DEVELOPMENT REVIEW BOARD  
SUPPLEMENTAL SUBMITTAL

PROJECT NO. 2020-004595  
Application No. SD-2021-0011

TO SUBDIVISION IMPROVEMENTS AGREEMENT  
DEVELOPMENT REVIEW BOARD (D.R.B.) REQUIRED INFRASTRUCTURE LIST  
ALBUQUERQUE RANCH ESTATES, UNIT II

## ALBUQUERQUE RANCH ESTATES, UNIT II ALBUQUERQUE, NEW MEXICO

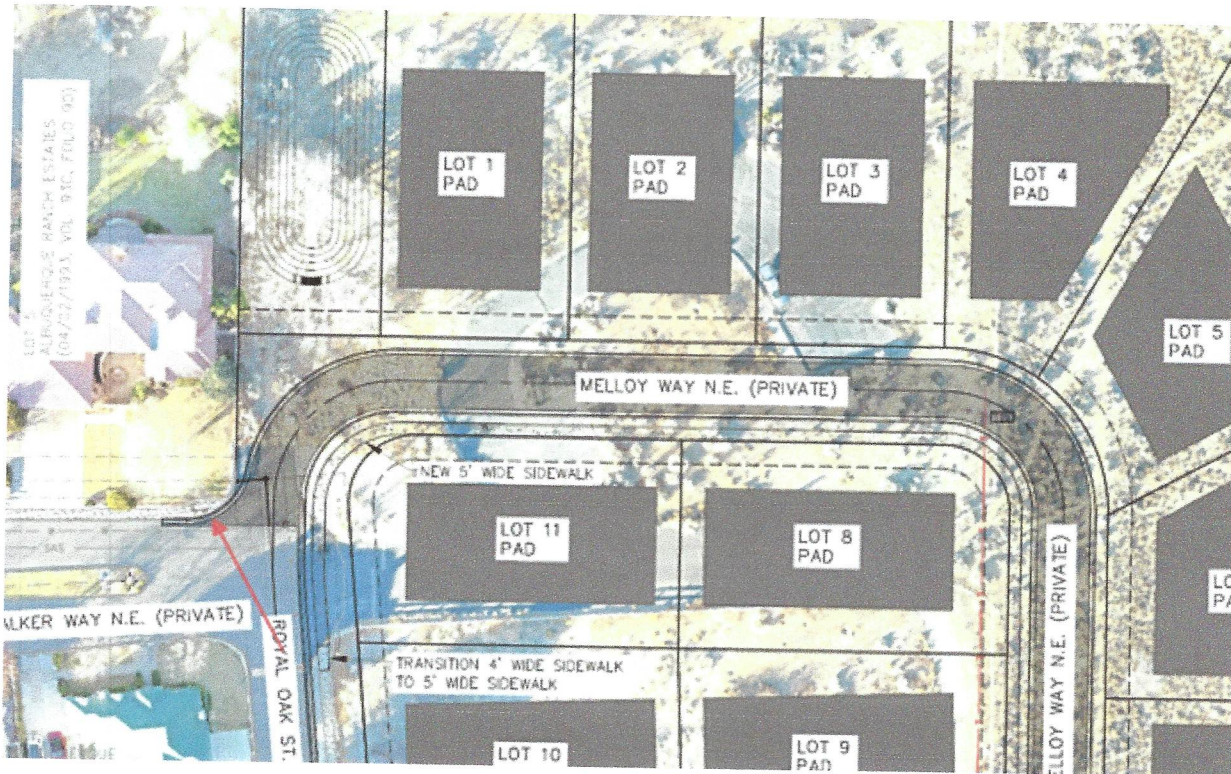
Can you remove the curb shown below?

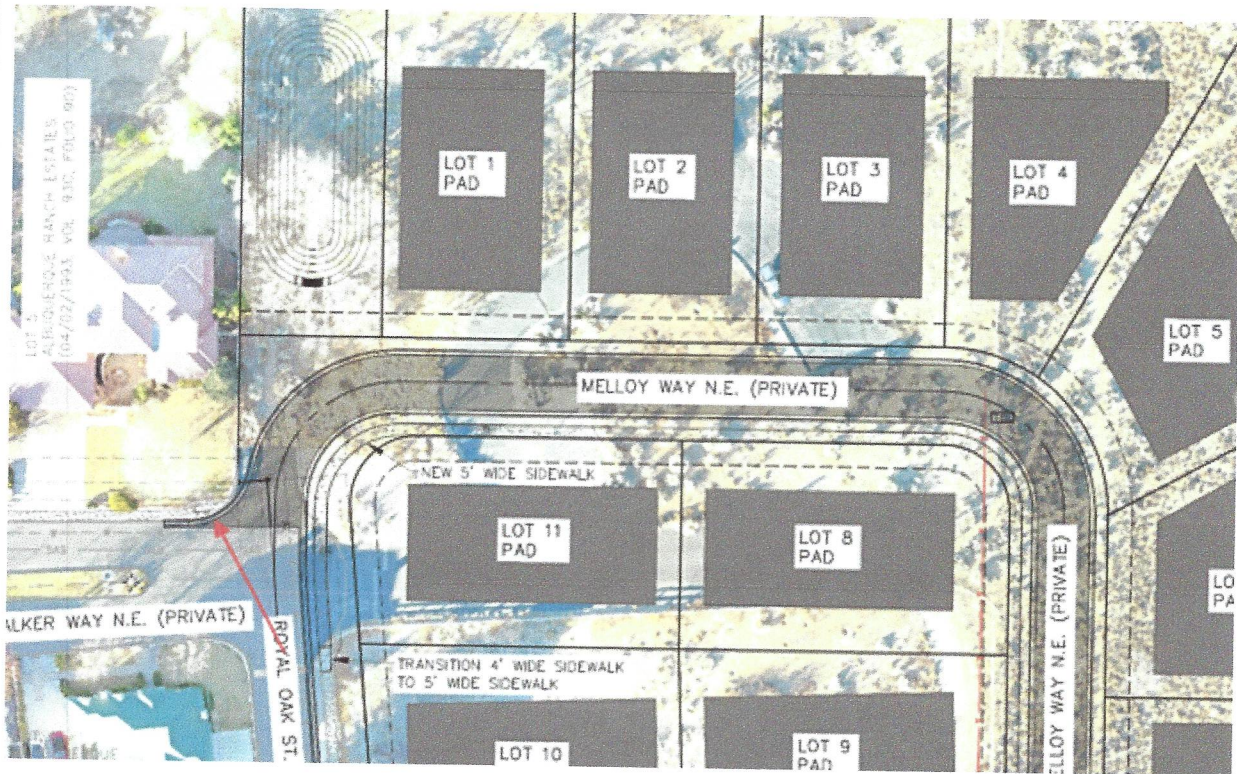
Can you remove the curb shown below?
